SECTION 00 9112
ADDENDUM NUMBER 2

DATE: 03/02/2021
PROJECT: CITY OF MILLERSBURG FIRE STATION 15
ARCHITECT'S PROJECT NUMBER: 20006
OWNER: CITY OF MILLERSBURG
ARCHITECT: SODERSTROM ARCHITECTS

9 TYP. RAKE @ WOOD ROOF
3" = 1'-0"

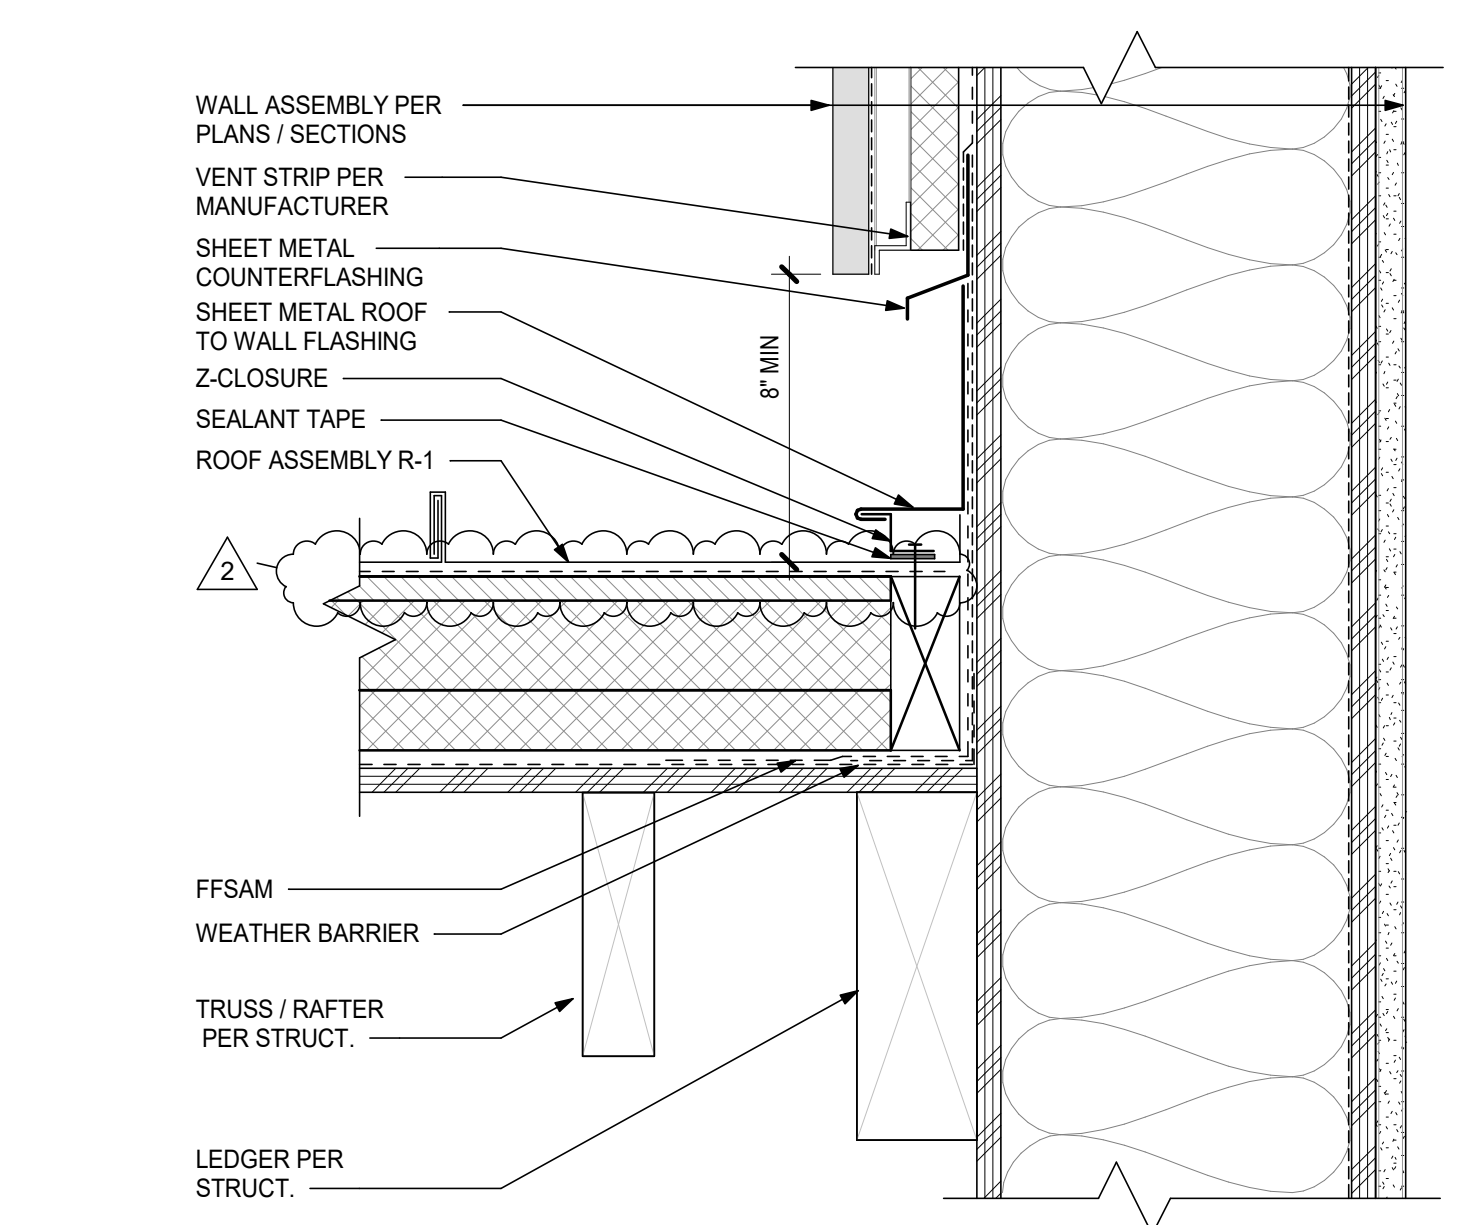
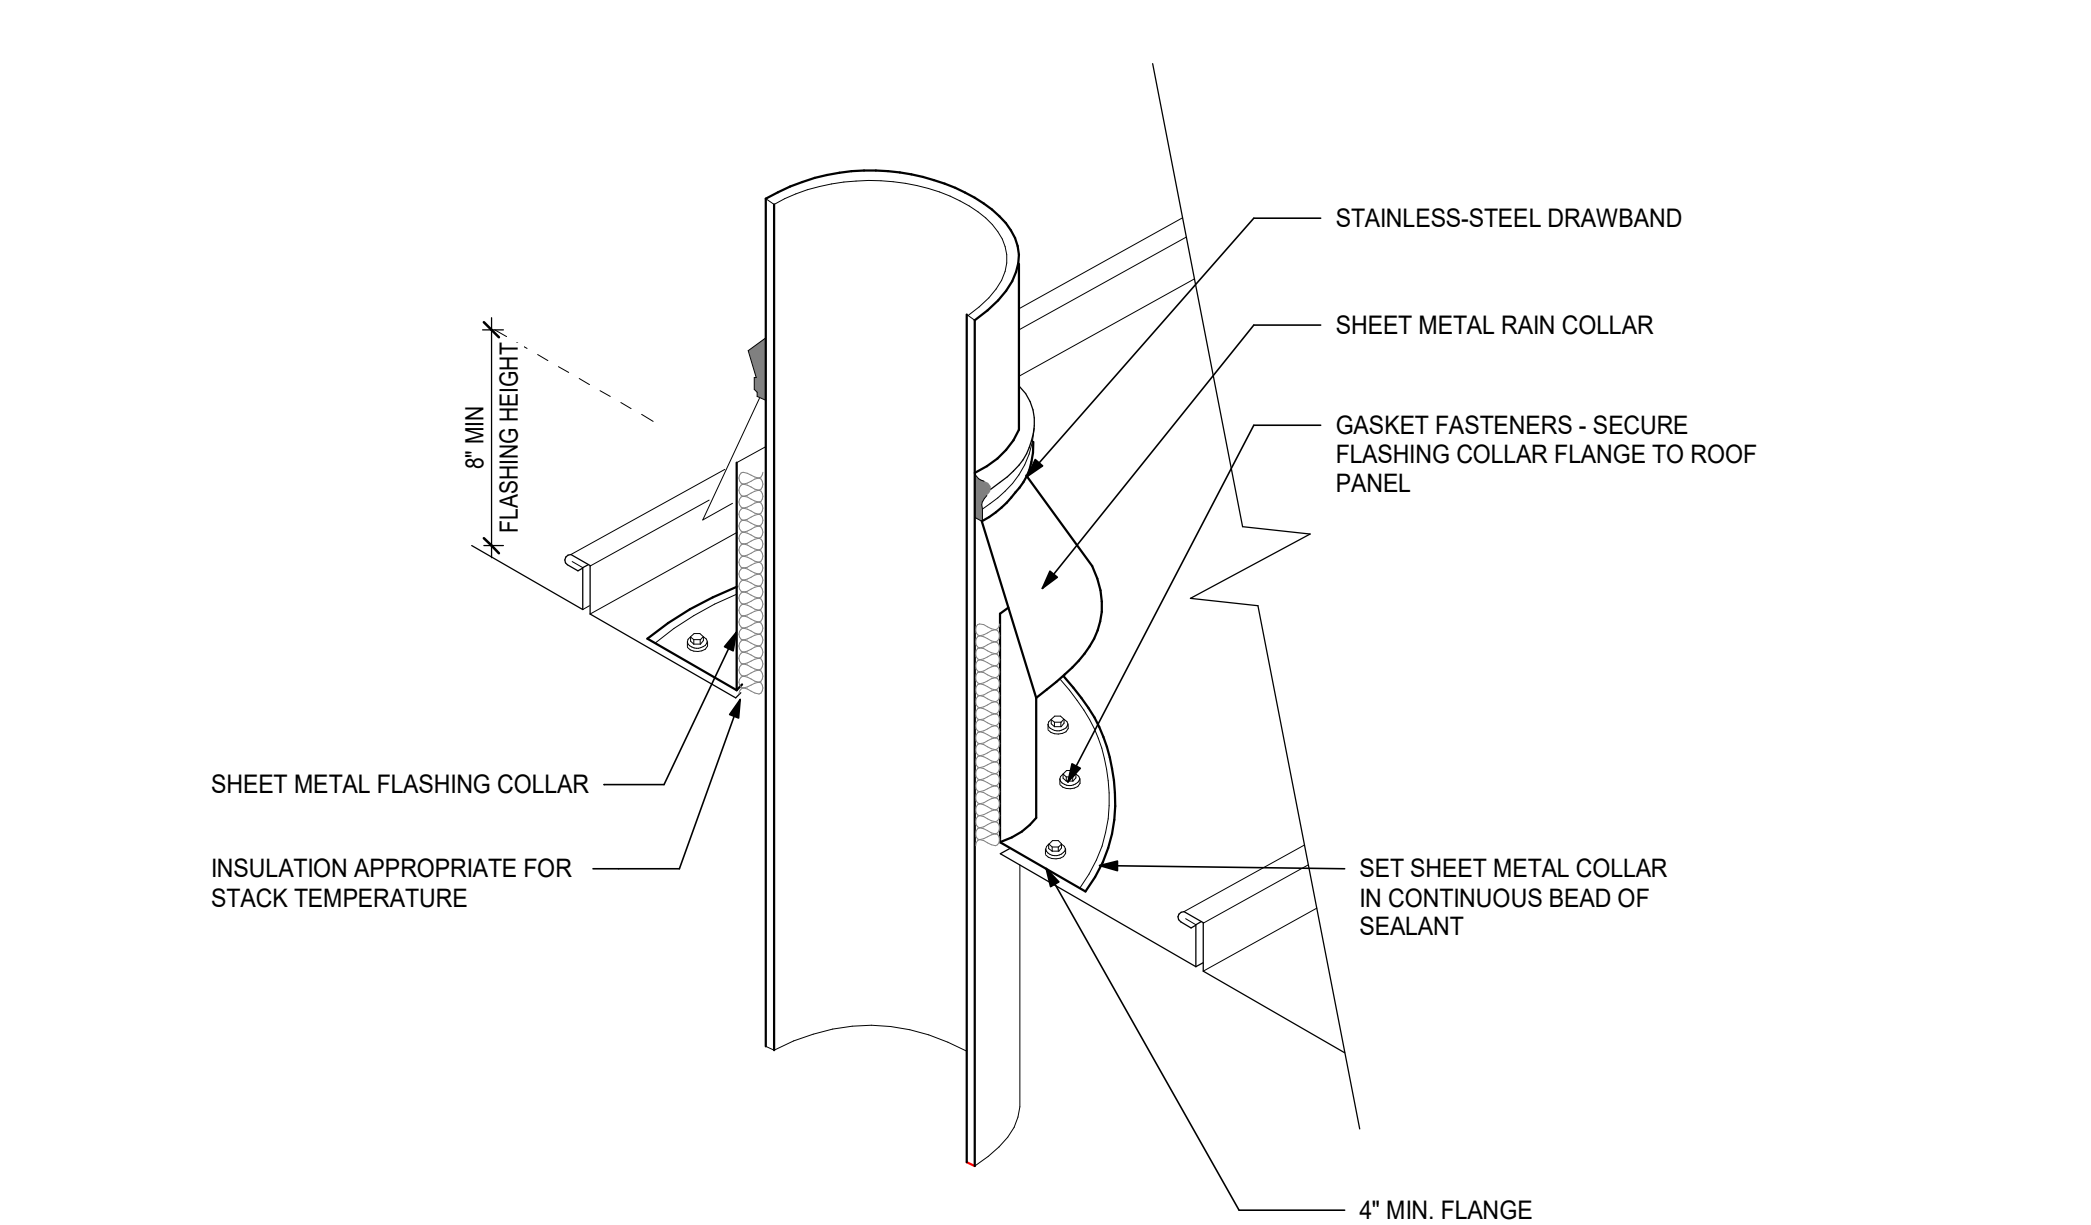
DRAWING A8.20

Revise Details 1, 5, 6, 7, 9, and 10 to show coverboard at insulation

Revise Details 6 and 7 to indicate underlayment lapped over Ice & Water Shield

Revise Detail 6 to remove reference to cedar fascia

- A. A 20" high LSL board will be used for fascia board at all locations. See revised details on A8.20 and revised Keynote 3004 on A3.01 and A3.02, reissued with this addendum.

- A. A cover board has been added to the roof assembly to allow for adherence of underlayment and ice and water shield. See revised A0.01 and A8.20 reissued with this addendum.

8 WORK COUNTER
1" = 1'-0"

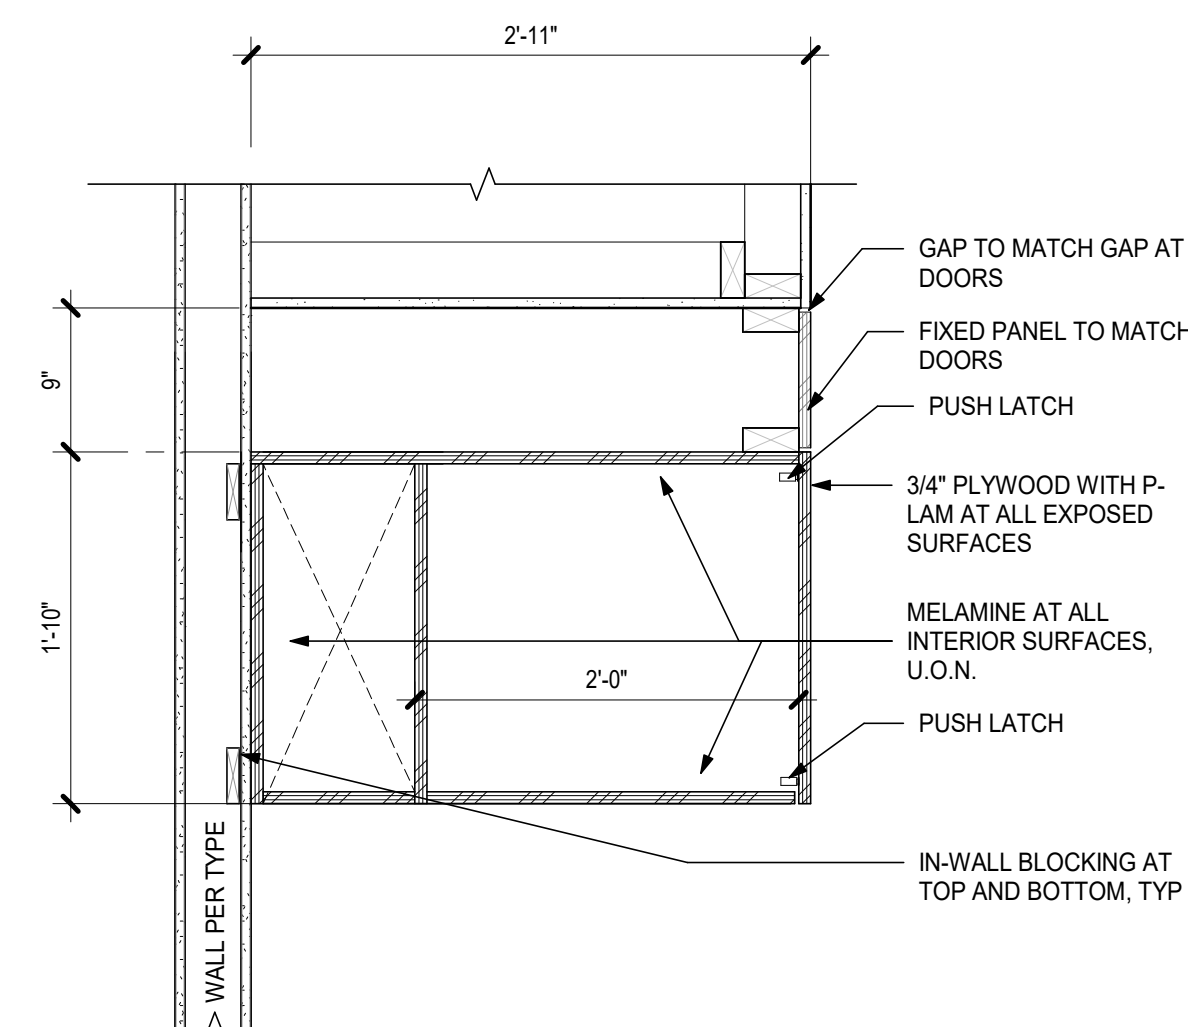
DRAWING A9.31

Revise Detail 8 to show bracket directly supporting countertop and attachment of bracket to wall.

1 EQUIPMENT PLAN

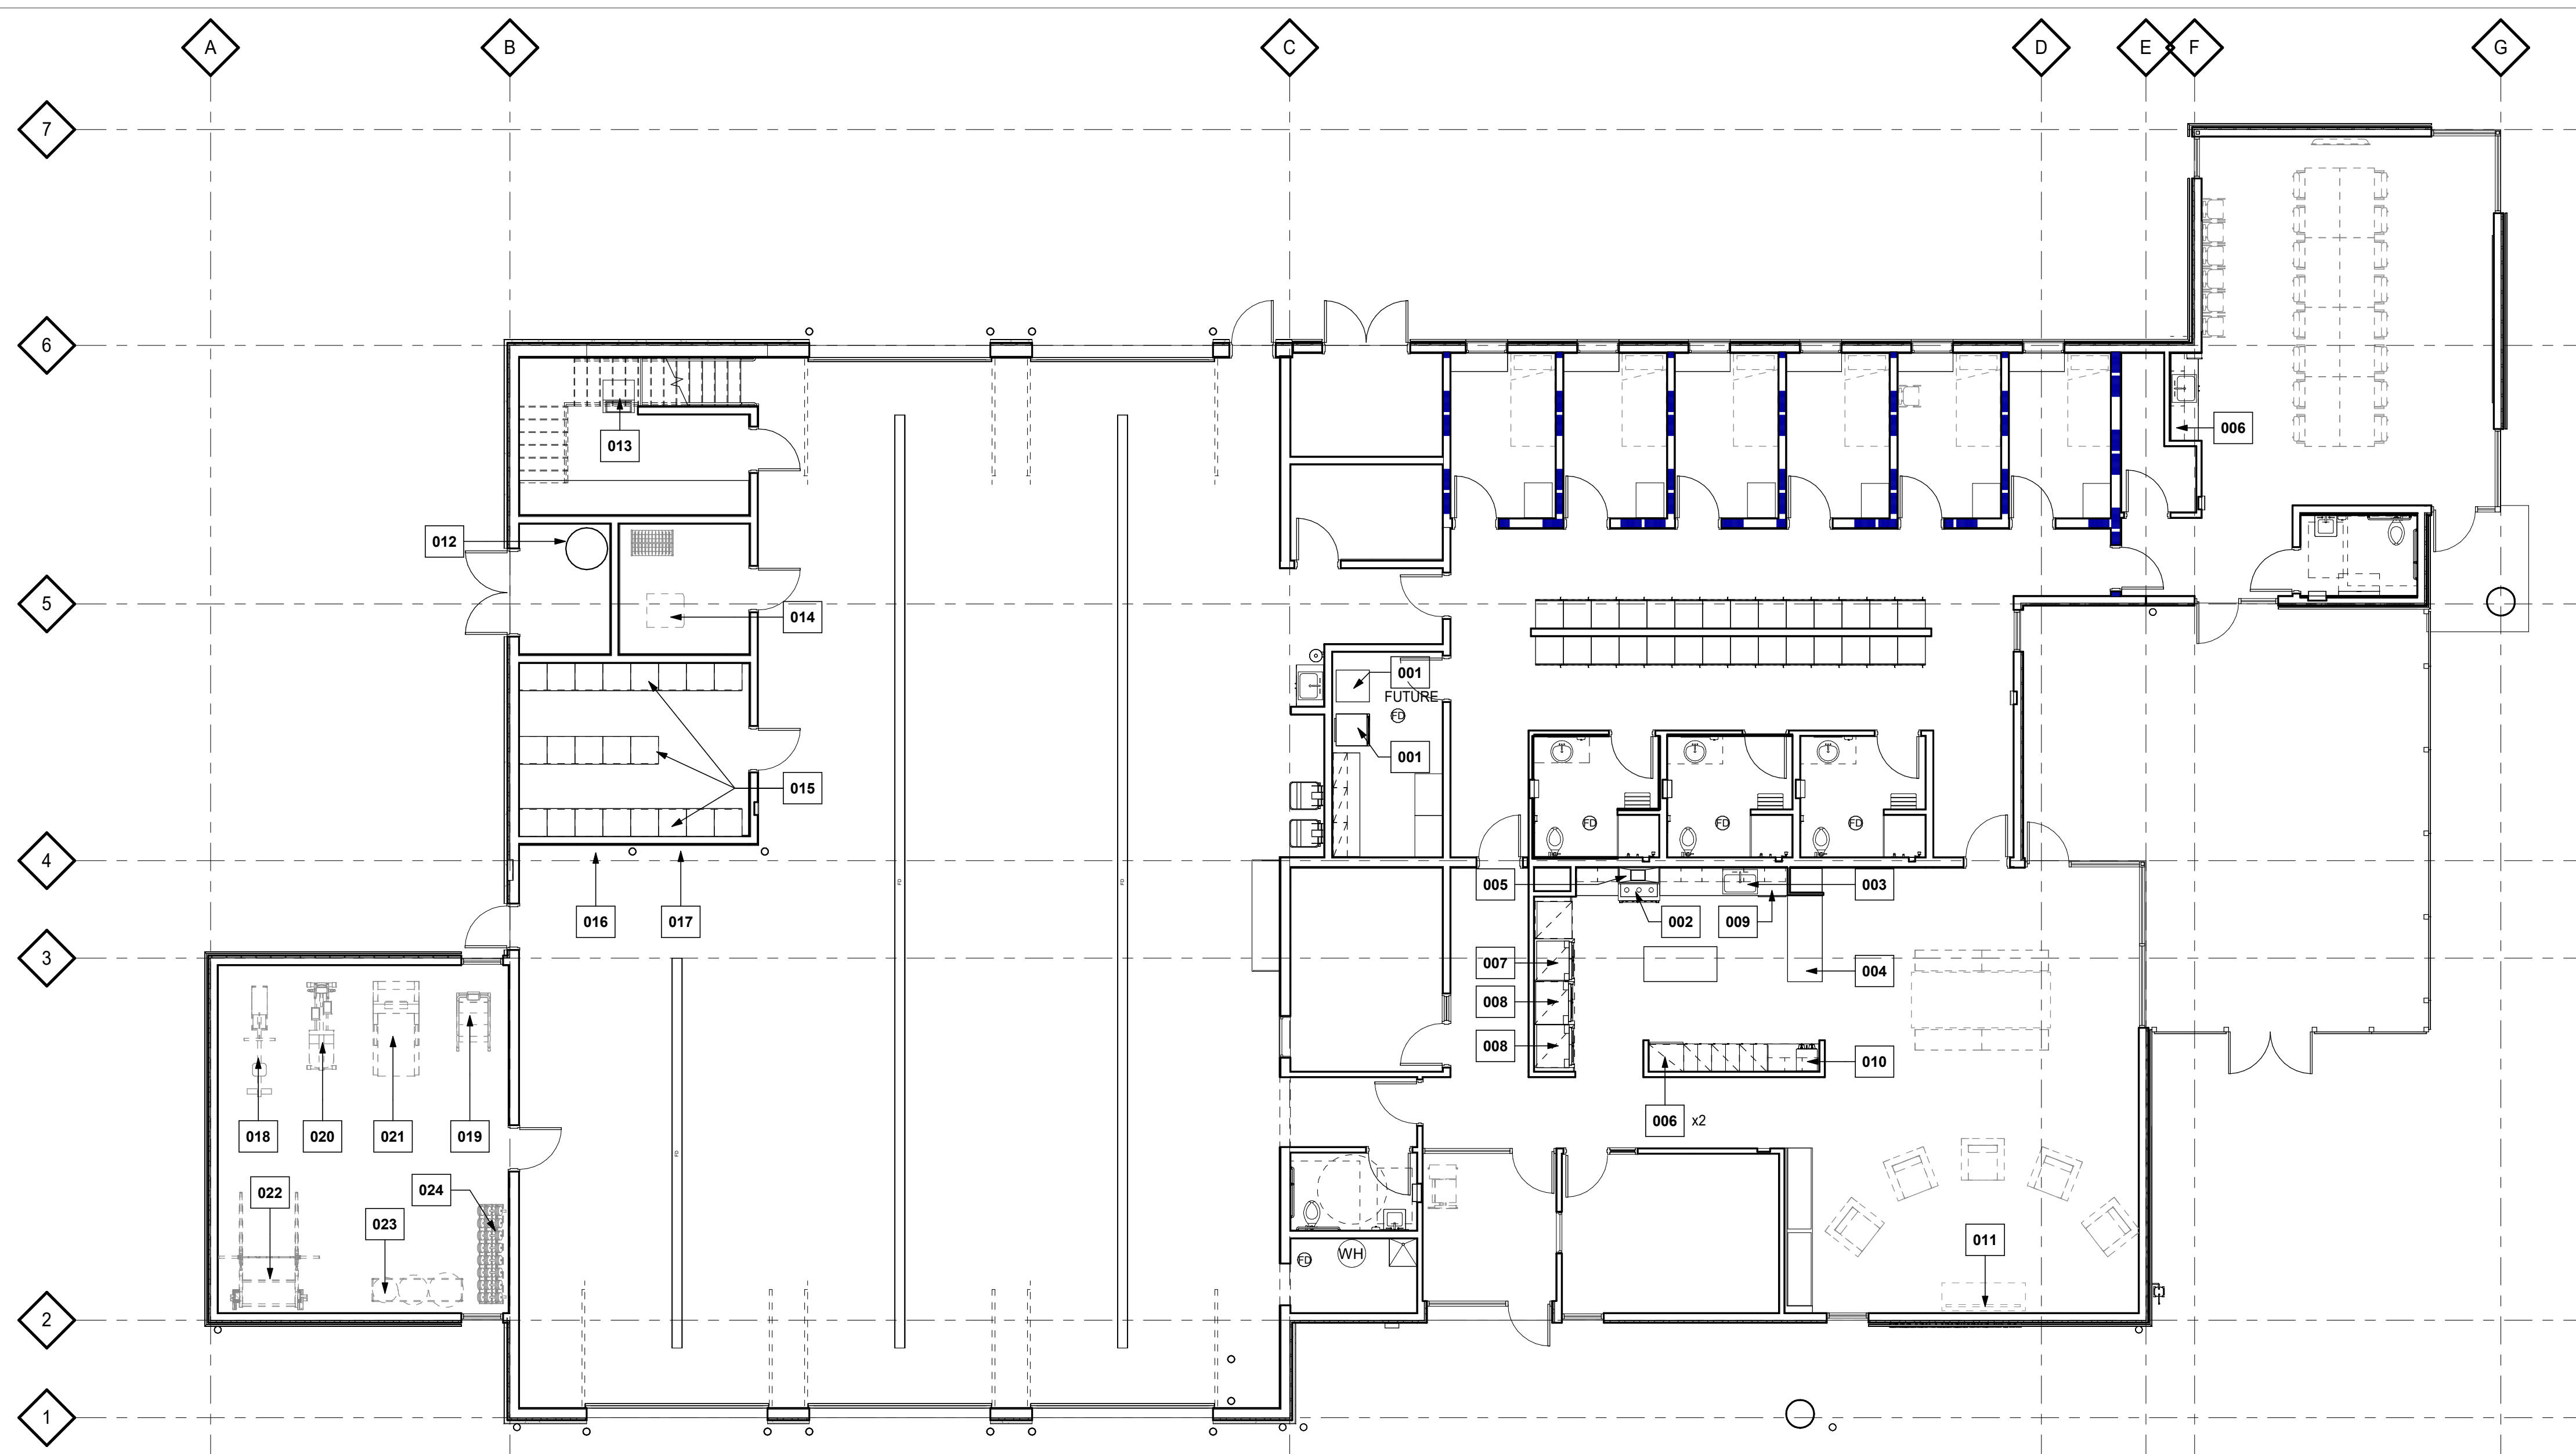
DRAWING EQ1.01

Revise Equipment Schedule Line 15 per clouded Items, Delta 2

15. **Need more info on the Turn Out Storage Racks. Keynote 2008 on sheet A2.01 states "Turnout Racks. Relocate (12) from Owner's Existing Facility. Provide (1) New Triple Rack and (3) New Double Racks". However, Equipment Schedule on EQ1.01 states that (9) additional racks are to be ordered. Please confirm total amount and size of additional racks needed. Also, there is no spec or additional info regarding model #, etc. to determine what to purchase, please provide.**

A. Specifications and product information are provided in Specification Section 10 5143 – Wire Mesh Storage Lockers. The racks listed in Keynote 2008 provide for (9) new individual locker spaces. Equipment Schedule on EQ1.01 has been updated to reflect this. See re-issued sheet EQ1.01
